# UNITED STATES PATENT AND TRADEMARK OFFICE

| APPLICATION NO. | FILING DATE | FIRST NAMED INVENTOR | ATTORNEY DOCKET NO. | CONFIRMATION NO. |
|-----------------|-------------|----------------------|---------------------|------------------|
| 10/730,834      | 12/08/2003  | Nick Kuo             | JCLA11759           | 5204             |

**Office Action Summary**

## DETAILED ACTION

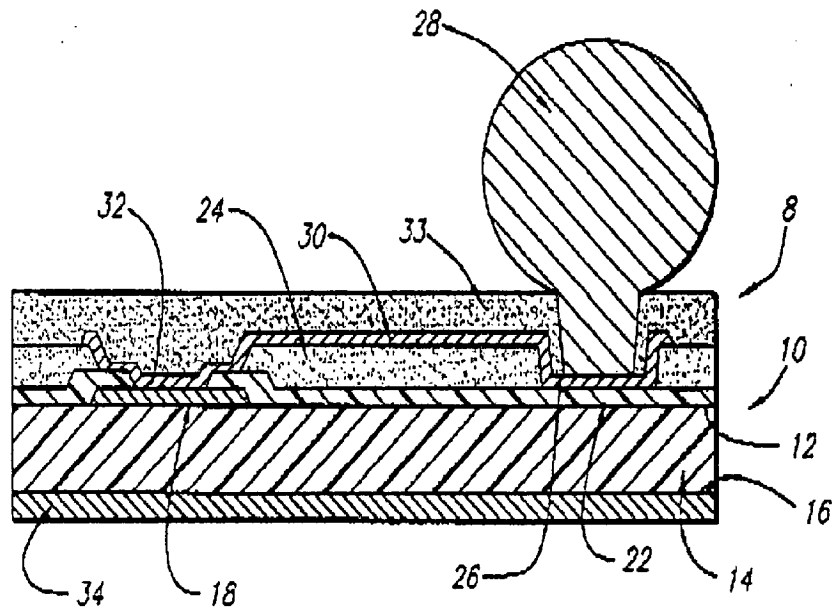
5. Regarding claims 1 and 3, Elenius (e.g. figs. 1 & 2) shows a substrate 14, a metallization structure 18 over the semiconductor substrate; a passivation layer 22 over the metallization structure 18, wherein an opening in the passivation layer exposes a top surface of the metallization structure and a patterned circuit 30 connected to the top

surface through the opening, wherein the patterned circuit layer comprises a first portion having a bump 28 formed thereover and a second portion connected to the first portion (col. 1/lls. 22-45 & col. 6/lls. 1-37).

FIG.3

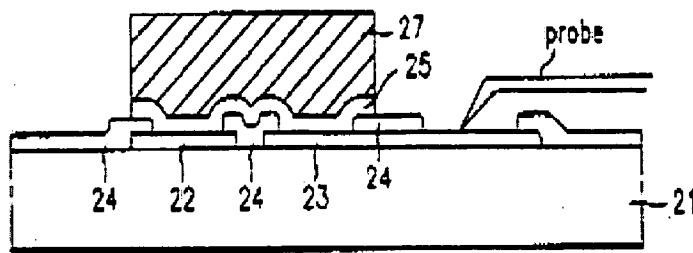
Elenius does not teach a testing pad or second portion used to be in contact with a testing probe and/or a patterned circuit layer comprising a gold layer. Therefore, Elenius in view of Kim does not teach that the gold layer has a thickness greater than one micron. Nevertheless, Kim (e.g. fig. 3) shows a patterned circuit layer connected to a top surface through an opening wherein the patterned circuit layer comprises a first portion used to have a bump 27 formed thereover and a second portion to be in contact with a testing probe whereon the first portion is connected to the second portion. This type of embodiment prevents decreases in testing reliability caused by damages on the surface of the bump and polluting material thereby enhancing its yield with respect to bonding (col. 2/lls. 10-30).

On the other hand, Sato teaches that pattern circuit layer comprising a gold layer of 2 microns (col. 34/35). It would have been obvious to one of ordinary skill in the art at the time the invention was made to include a second portion used to be in contact with a probe to prevent decreases in testing reliability caused by damages on the surface of the bump and polluting material during the testing process, thereby enhancing its yield with respect to bonding as taught by Kim and to make the pattern circuit layer disclosed by Elenius in view of Kim comprising gold layer of 2 microns as suggested by Sato to increase the electrical conductivity of the patterned circuit layer and because it has been held to be within the general skill of a worker in the art to select a known material on the basis of its suitability for the intended use as a matter of obvious design choice. In re Leshin, 125 USPQ 416
